DAC8871 Output connection

Output of OPA, add 47pF at the DAC output
Code change: 8000h \rightarrow 7FFFh

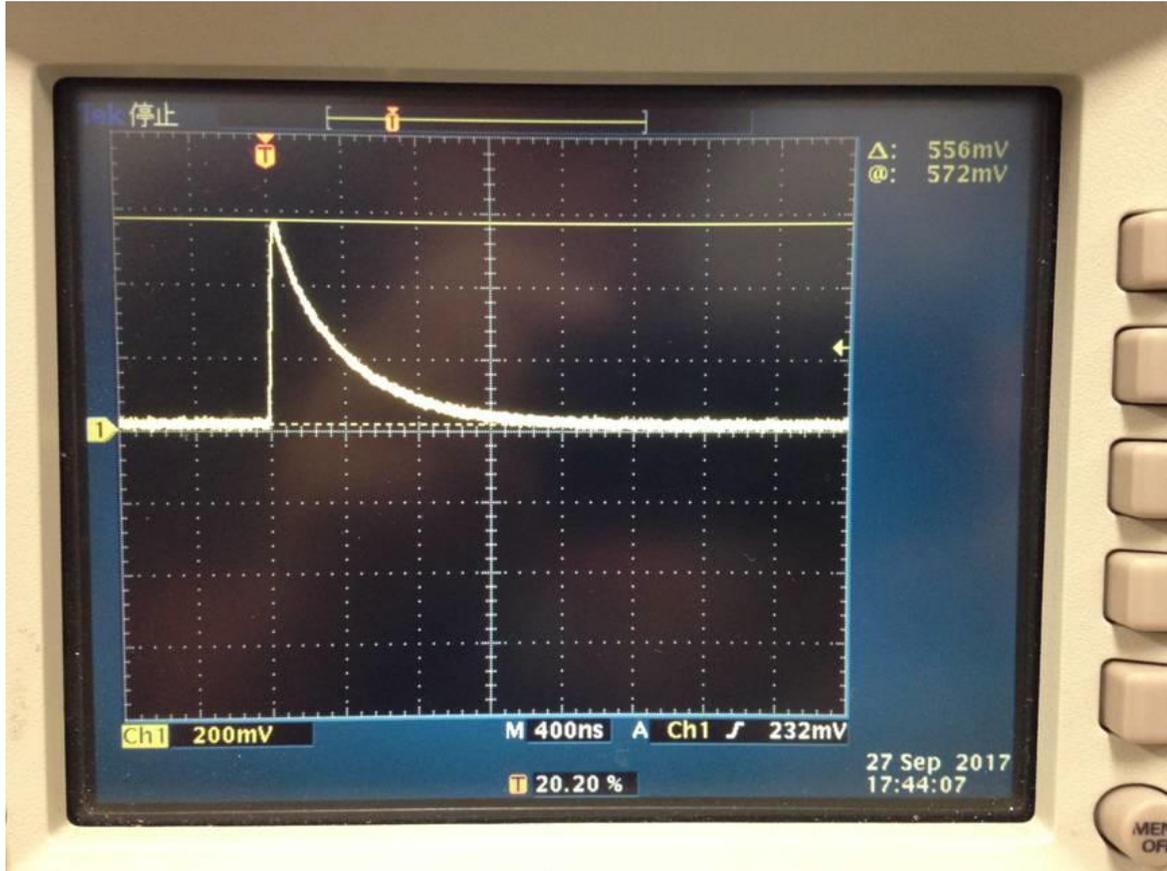
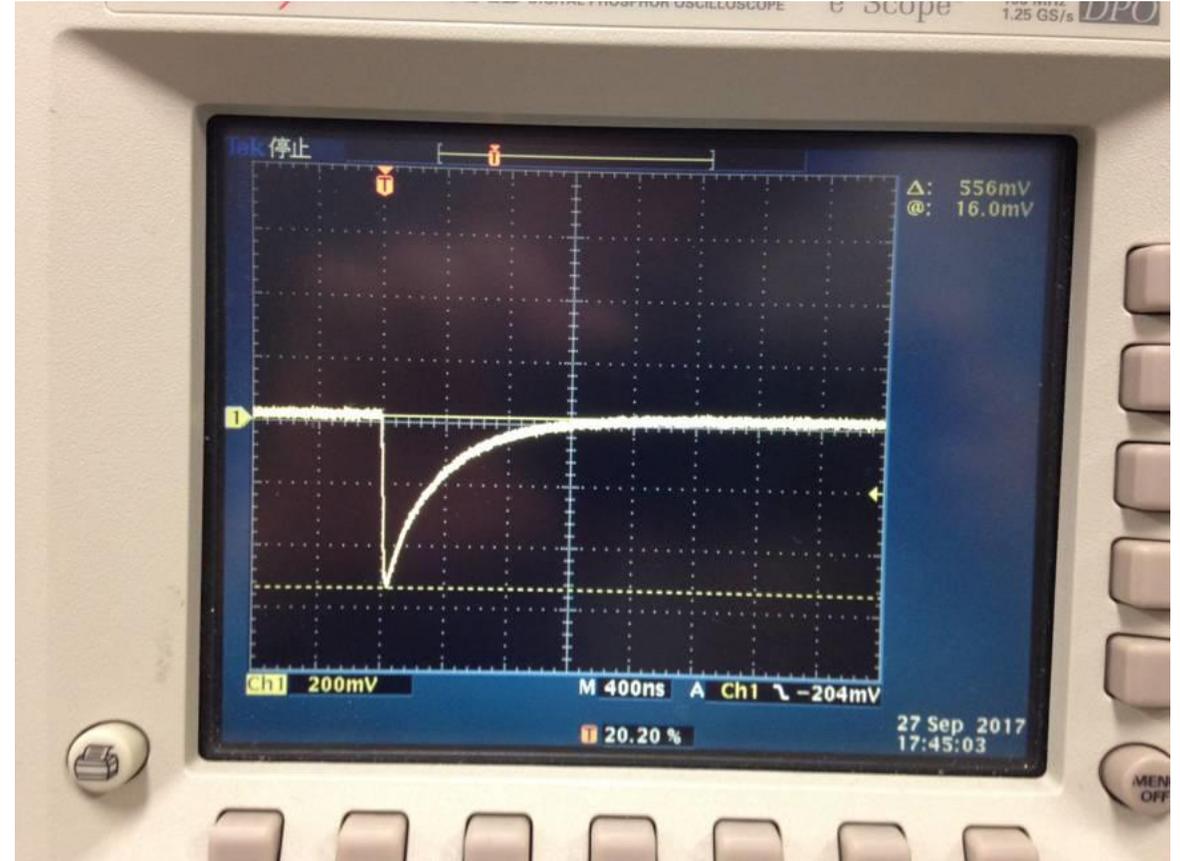
Output of OPA, add 47pF at the DAC output
Code change: 7FFFh \rightarrow 8000h

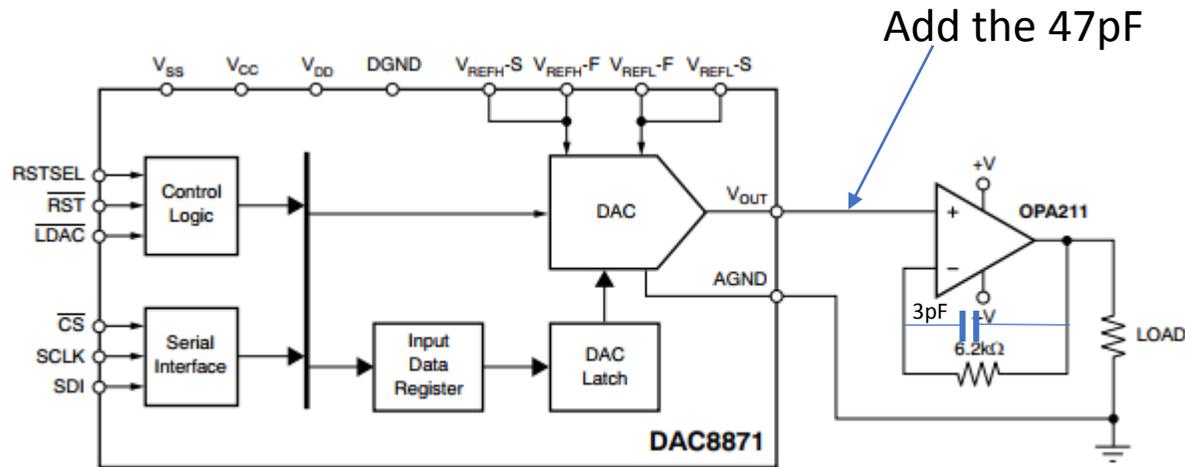
Can we add the capacitor at the Vout?

Could you please let me know if there is any concern?

I appreciate it if you have any other countermeasure of this glitch.

Since our customer glitch target is less than +/-400mV, they would like to increase additional capacitor.

Are there any limit of additional capacitor?

Could you please let me know if recommended maximum capacitance at Vout?
